# A303 Sparkford to Ilchester Dualling Scheme TR010036

### 9.27 Deadline 6 Report

#### **Deadline 6 Report**

Figure 1: Extract of plan contained within Appendix A of the Drainage Strategy Report (APP-060)

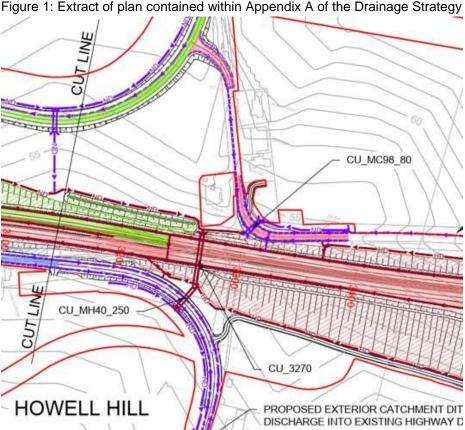
#### **Second Written Question 2.8.1 Climate Change**

1.4.8 The proposed culvert under the dual carriageway (reference CU\_3270 shown on Figure 1 below, which is an extract of the drainage strategy drawings contained within Appendix A of the Drainage Strategy Report, APP-060) is only intended to convey natural surface water runoff which would otherwise run onto the new connecting carriageway and the new dual carriageway – such drainage is annotated on Figure 1 below and the plans within Appendix A of the Drainage Strategy Report (APP-060) with the initials 'ND'. Runoff from the highway surface of the new connecting carriageway and the existing surface of the Steart Hill highway (north of the proposed dual carriageway) will

- be conveyed to the new dual carriageway drainage system where it will be attenuated and then eventually discharged to the River Cary.
- 1.4.9 A short section of Howell Hill will be realigned to reconnect to the de-trunked existing A303 and runoff from this section of highway will discharge, without attenuation, into the existing Howell Hill drainage system. However, the surface area of this section will be less than the section of Steart Hill highway being diverted into the dual carriageway system and therefore the proposed design is considered to provide a betterment than the existing case.
